IN THE DRAWINGS

REMARKS

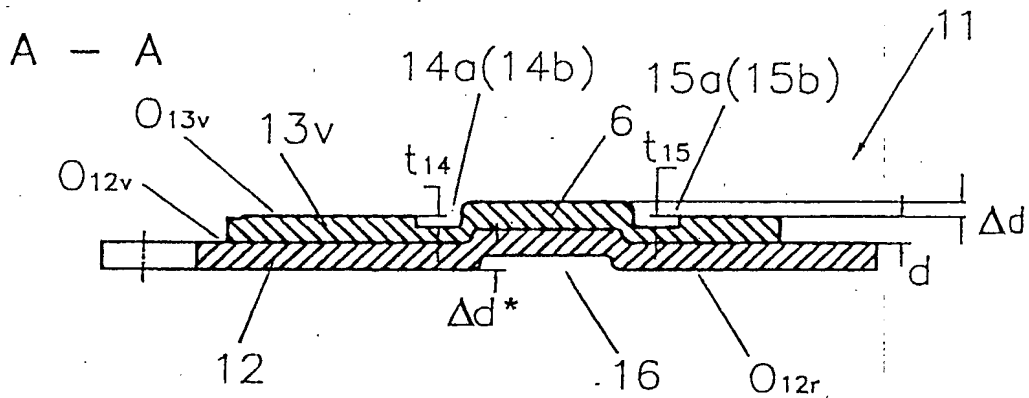
Please amend the drawings. The parts of Fig. 5 have been labeled Fig. 5A, 5B, and 5C pursuant to the Examiner's requirement. A sheet showing the changes marked in red and a replacement sheet with the changes are attached hereto.

The parts of Fig. 5 have been labeled 5A, 5B and 5C, as requested.
